AGENDA SECTION: PUBLIC HEARINGS	ORIGINATING DEPT: PLANNING	ITEM NO. E-6
ITEM DESCRIPTION: Amendment to General Development Plan #83, known as the Arboretum by Cordul Establishment and Michael Younge. The applicant is proposing to add approximately 3.08 acres of land to the Arboretum Special District (SD#1) and amend the General Development Plan to designate the property for "commercial" uses. The applicant is also requesting a Substantial Land Alteration permit to change grades on the site by 10 feet or more. The property is located north of 41 st Street NW, east of Arboretum Drive NW.		PREPARED BY: Theresa Fogarty, Planner

CORDUL/RET PROPERTIES
 ROCHESTER, MINNESOTA
SUBSTANTIAL LAND ALTERATION

RE: Amendment to General Development Plan #83, known as the Arboretum by Cordul Establishment and Michael Younge. The applicant is proposing to add approximately 3.08 acres of land to the Arboretum Special District (SD#1) and amend the General Development Plan to designate the property for "commercial" uses. The applicant is also requesting a Substantial Land Alteration permit to change grades on the site by 10 feet or more. The property is located north of 41st Street NW, east of Arboretu

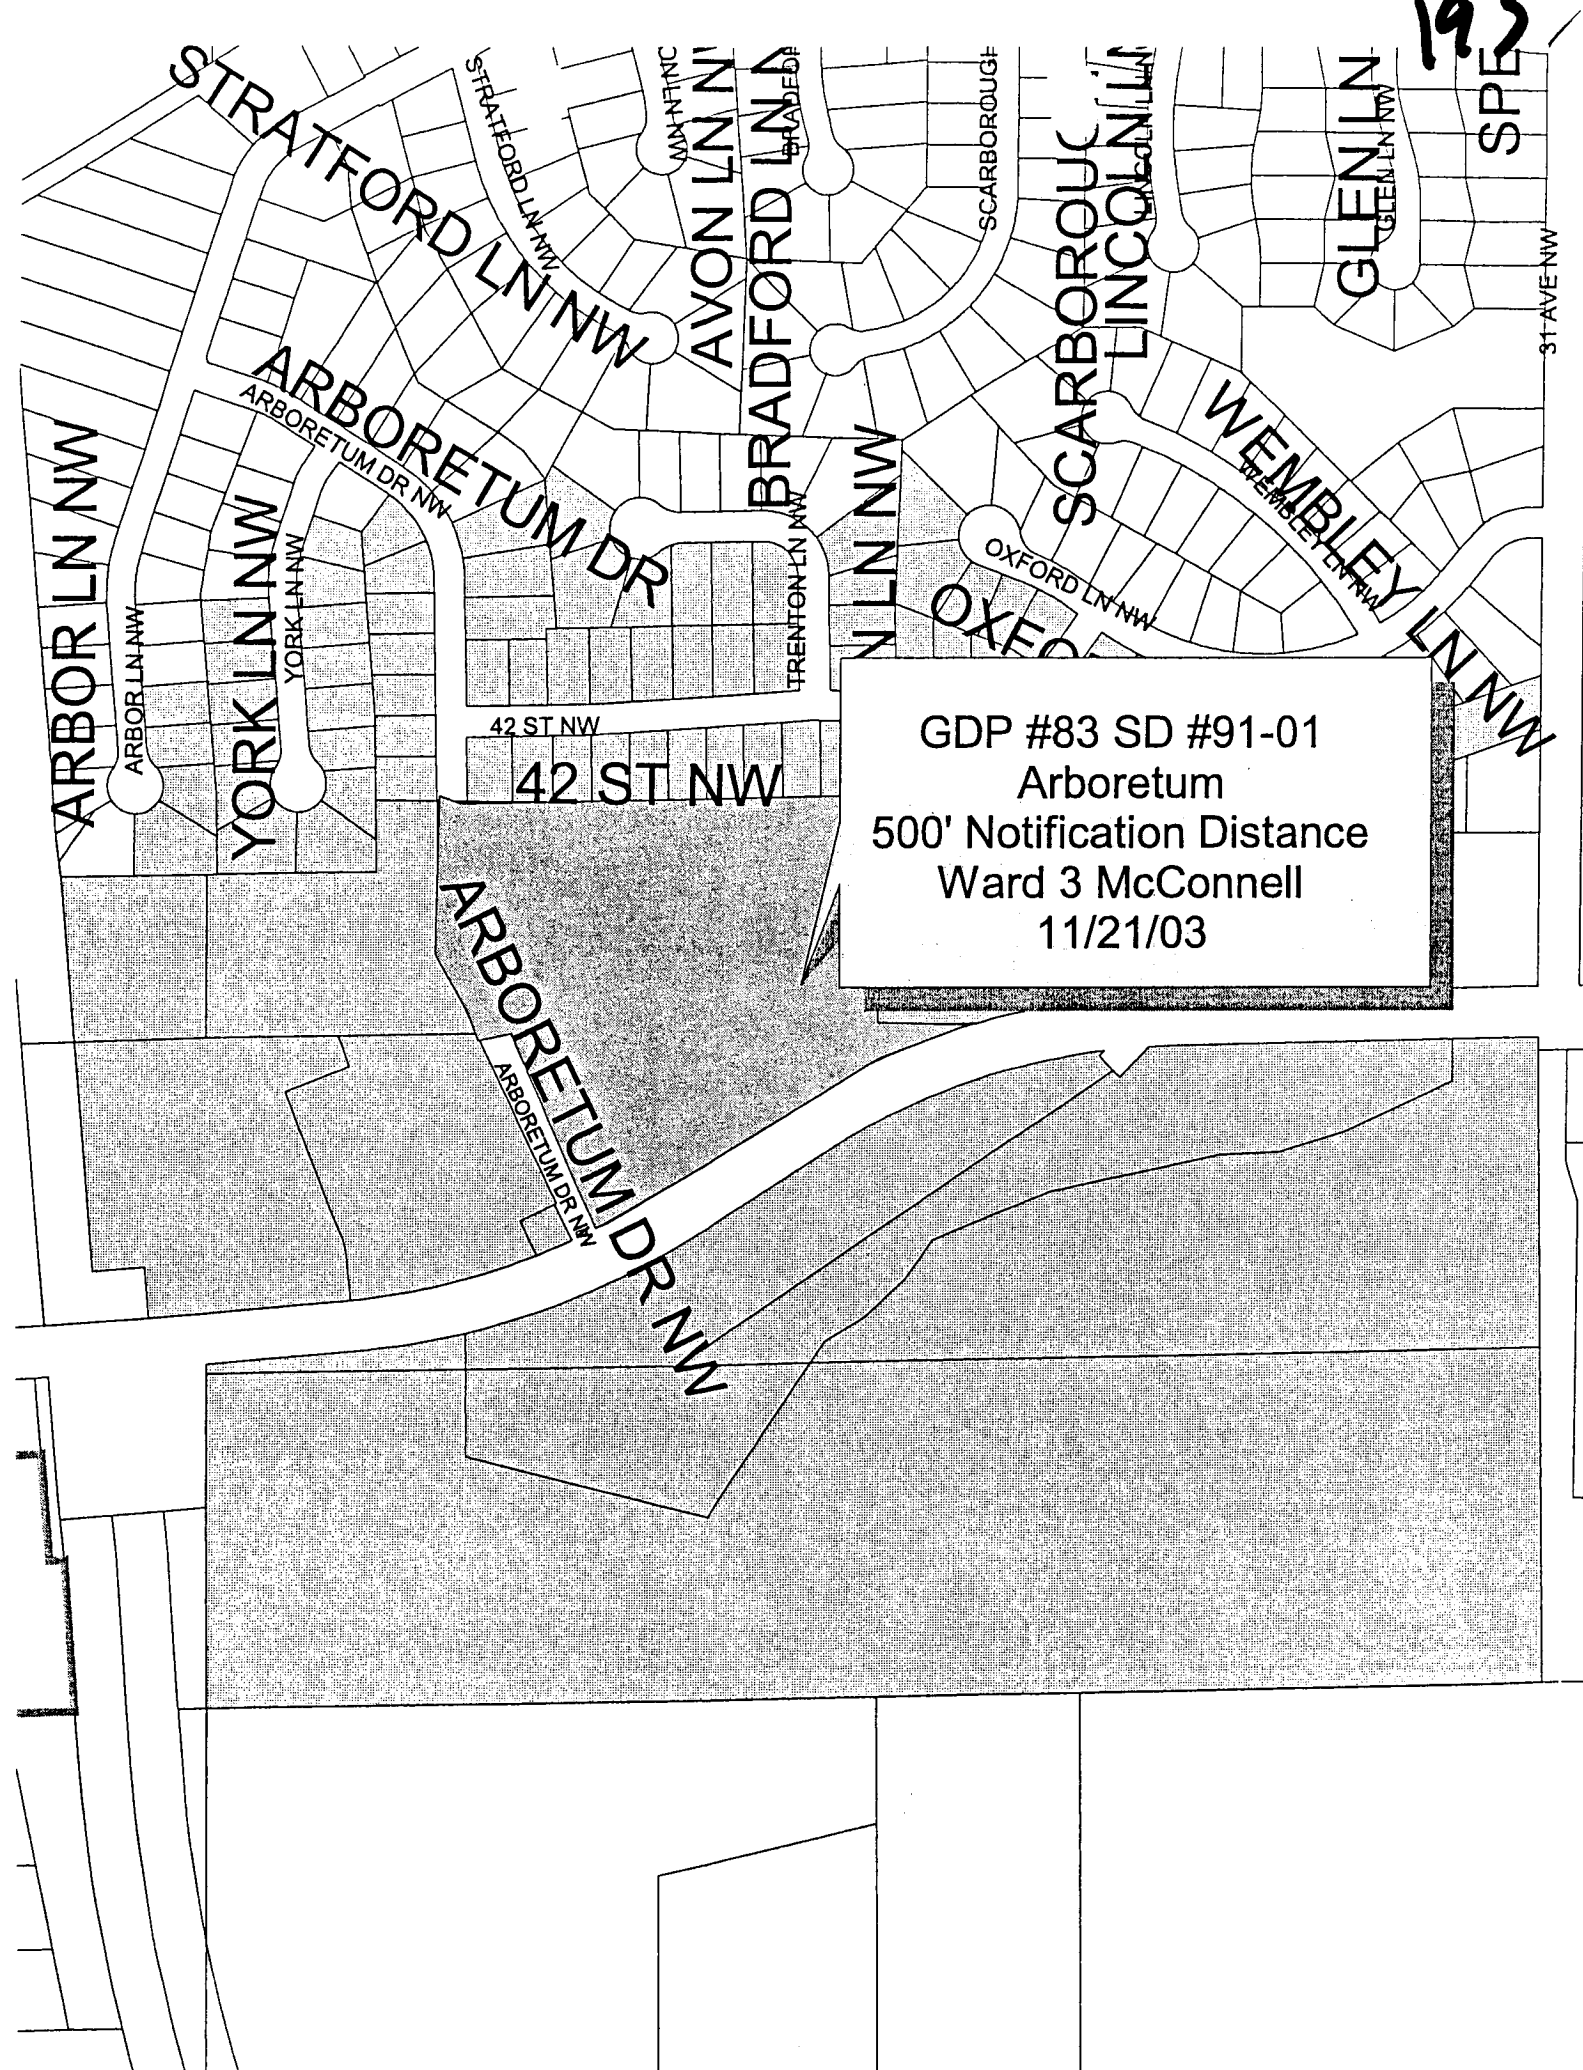
This development includes a proposal to change the grade in excess of a 10 foot vertical cut/fill from the pre-existing grades. The area where the grade is proposed to be changed, is located within the northern portion and southwestern portion of the GDP.

- 1) The activity should not result in danger to life or property. The street slopes on the site will be a maximum of 8% or less. The grading and drainage plans will need to comply with City standards and be approved by the Rochester Public Works Department.

- 2) The grading plan for this project needs to be approved by the Rochester Public Works Department and it will document the extent of the work. All cut material will be used on-site, therefore it will not be necessary to haul fill from the site. Noise and dust control will need to comply with City standards.
